**PERMIT REPORT**

Re: Permit 11-140F Woodland Cove Lake 3rd Addition, Minnetrista

Board Action Requested:

Figure 3: Proposed Irrigable Greenspace

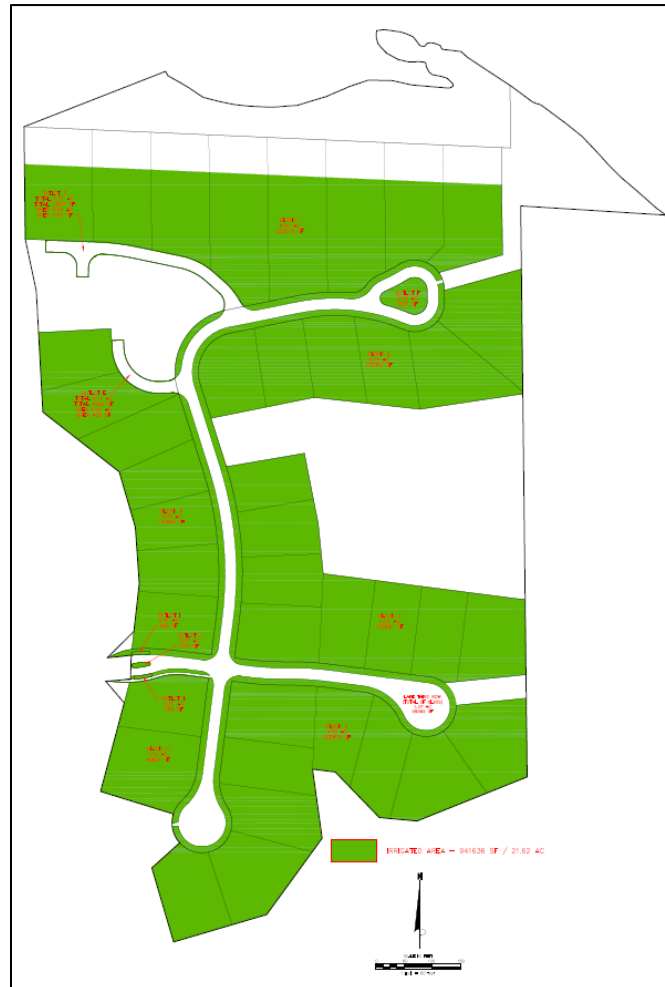
Through the information submitted by the Applicant, staff and the District Engineer have determined that the geo-technical constraints demonstrated preclude infiltration. Therefore, in order to provide stormwater treatment under these geo-technical conditions, the Applicant proposes to utilize a stormwater irrigation and re-use system. The system retains water in a large pond reservoir, and through use of a specialized pump, moves retained stormwater through an irrigation piping network, utilizing the stormwater on available greenspace, as shown in Figure 3. The design of the irrigation system follows best engineering practices as outlined in the Minnesota Stormwater Manual and the District's Stormwater Management rule. This includes submission of materials sufficient to demonstrate that:

- Sufficient pervious greenspace is available for irrigation;
- The stormwater re-use volume available in the reservoir pond both:
 - Below the primary outlet; and,
 - Above the required dead pool of the pond, maintaining at least 4 feet of depth for water quality;
- The ability to pump and irrigate the pervious areas within a 48-hour period of a storm event.

The District Engineer has reviewed and determined that the above criteria have been met for the proposal.

WETLAND #7

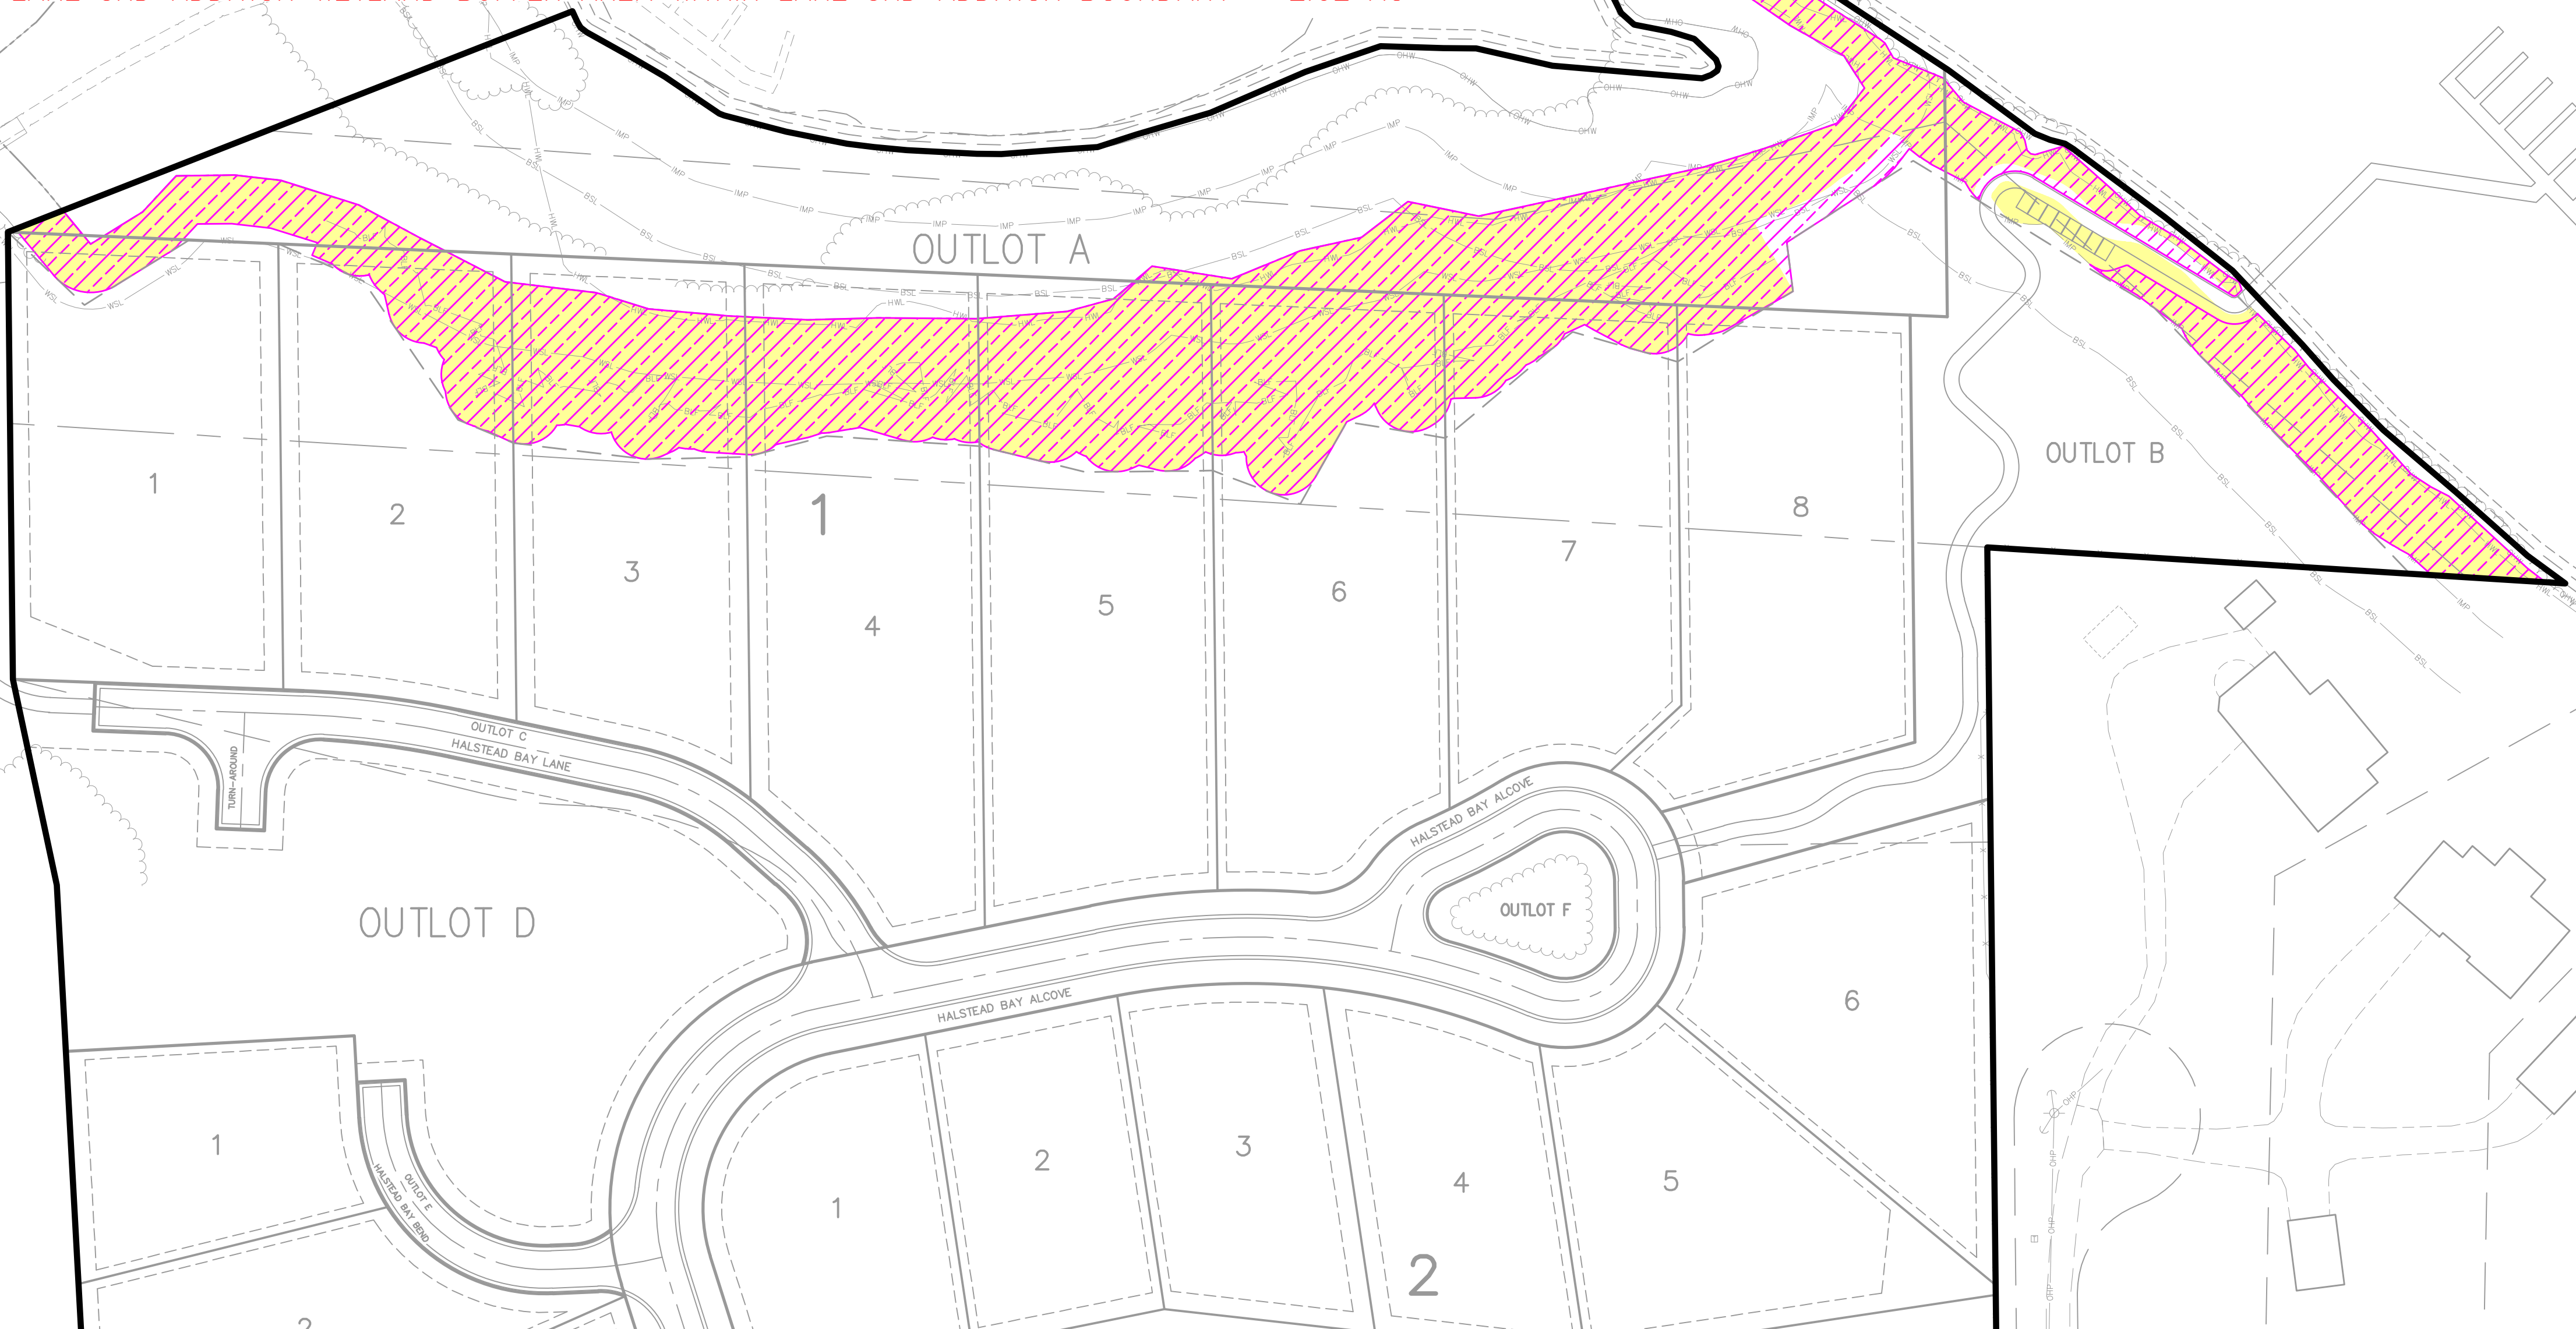
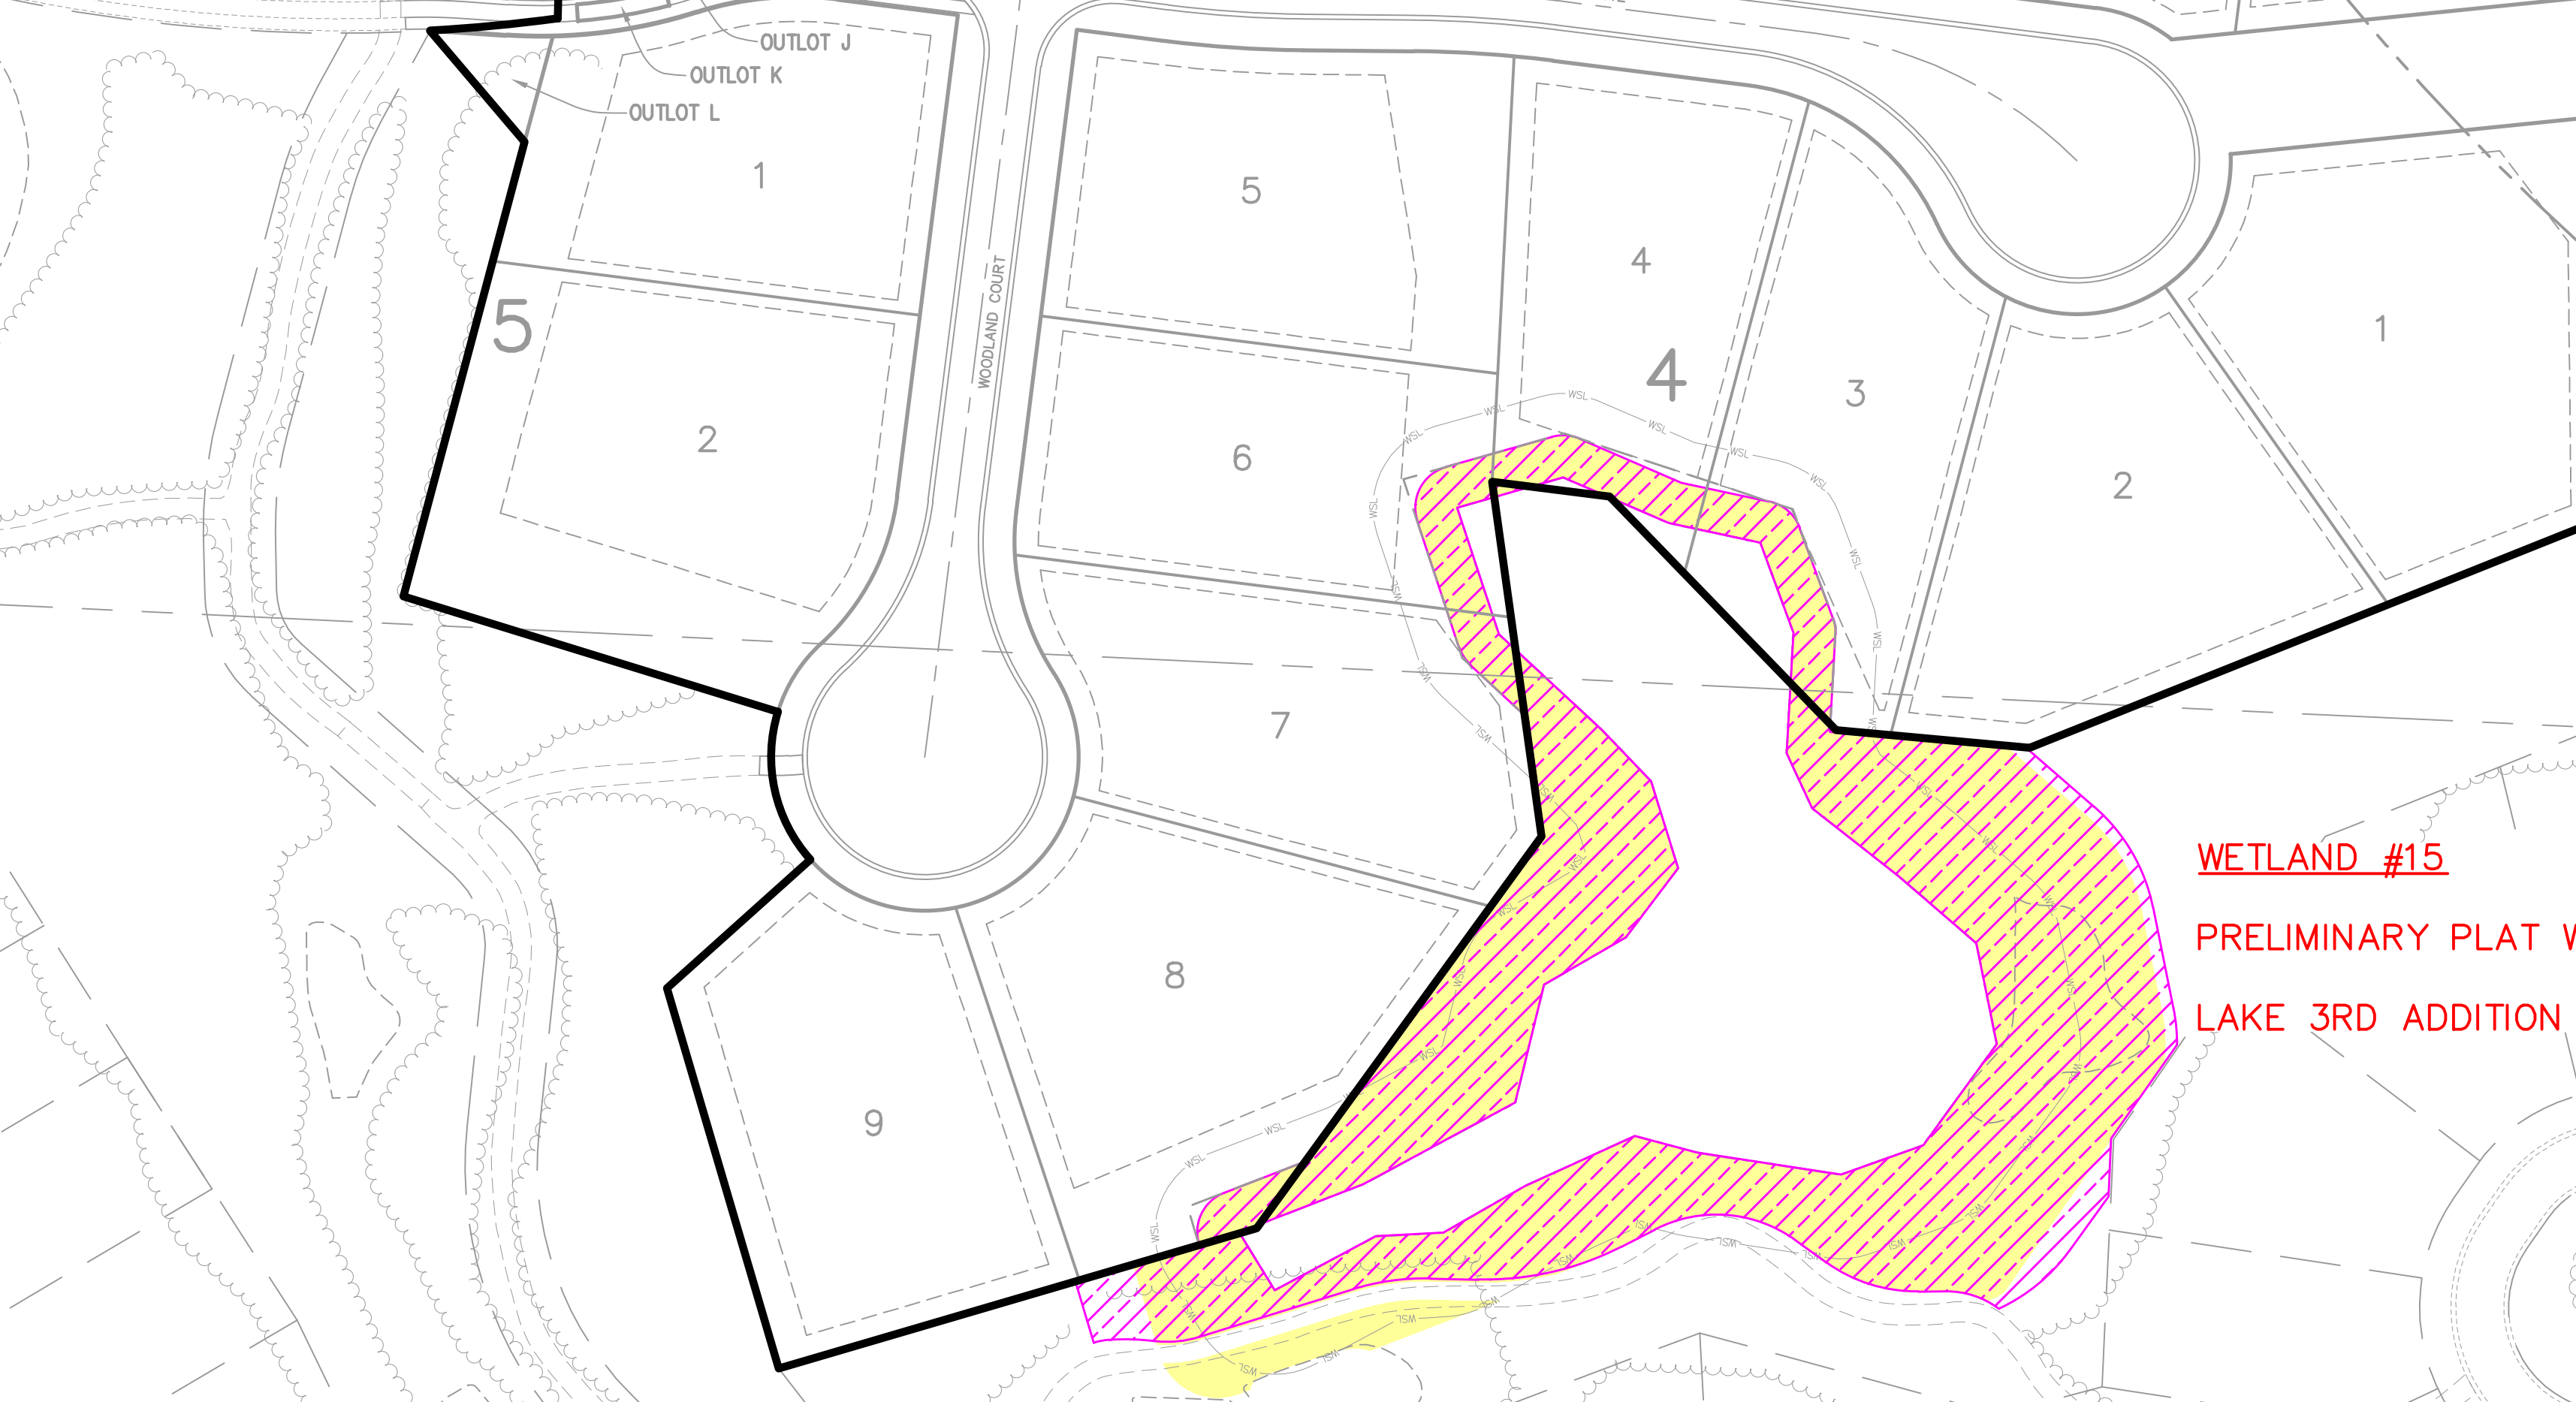
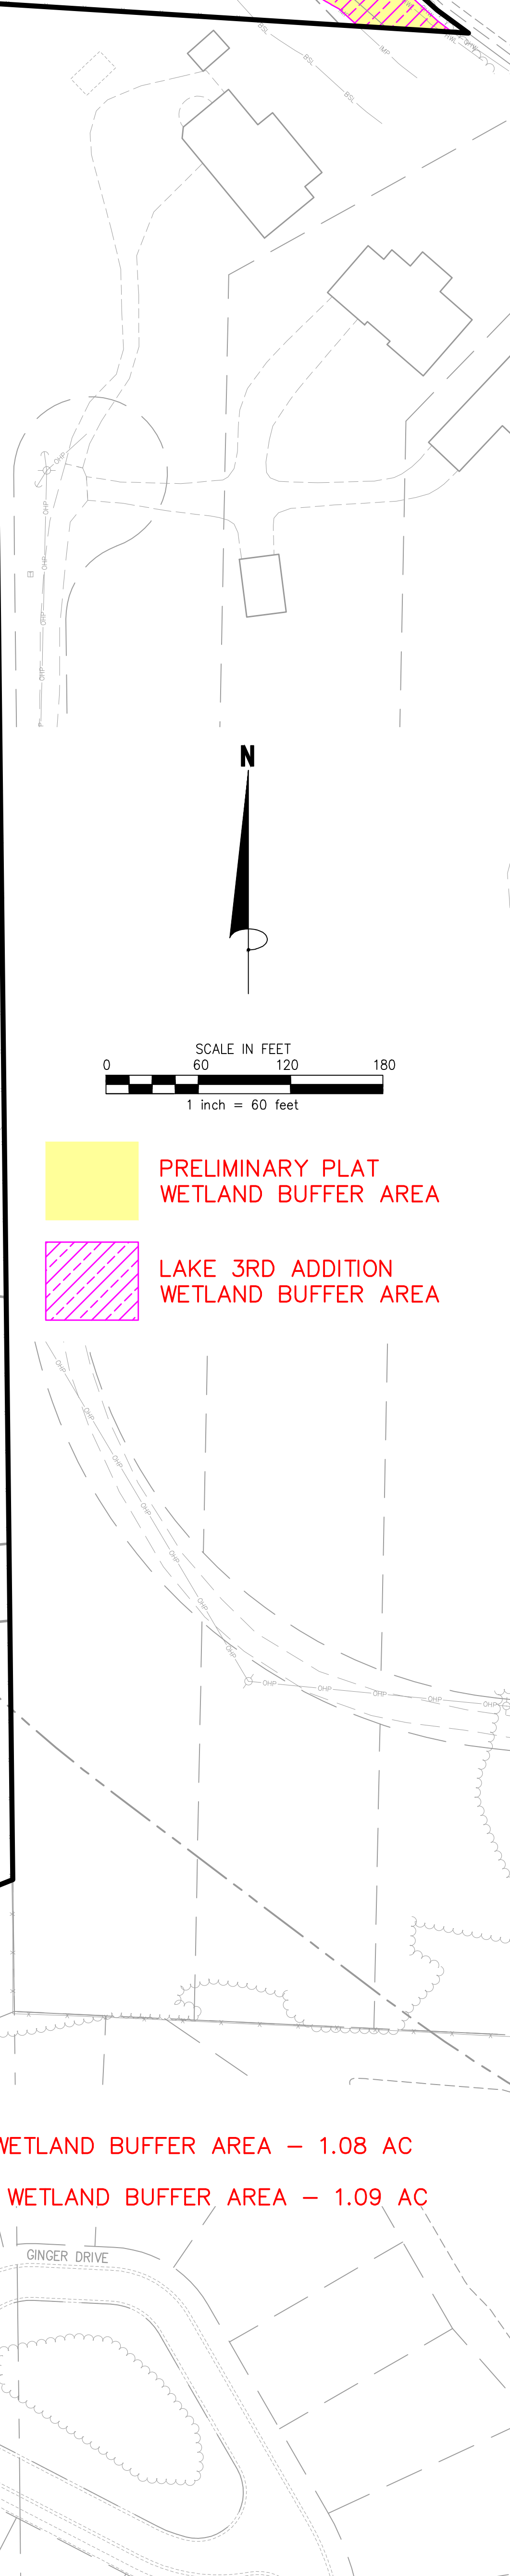
Per section 6(c) of the rule, buffer averaging is permitted should the full width of the buffer not be able to be provided in all locations. Under the provisions of the Board approval through permit #11-140, this phase of the overall Woodland Cove development proposed 3.89 acres of total buffer area. The current proposal has revised buffer areas to provide .02 additional acre of buffer, totaling 3.91 acres of buffer for the project. Based on staff's review of the information submitted by the Applicant, the adjustment of buffer width conforms to the rule's averaging standard.

In summary, the project meets the requirements of the Wetland Protection Rule as outlined in the 11-140 approval with the inclusion of .02 acre of additional buffer.
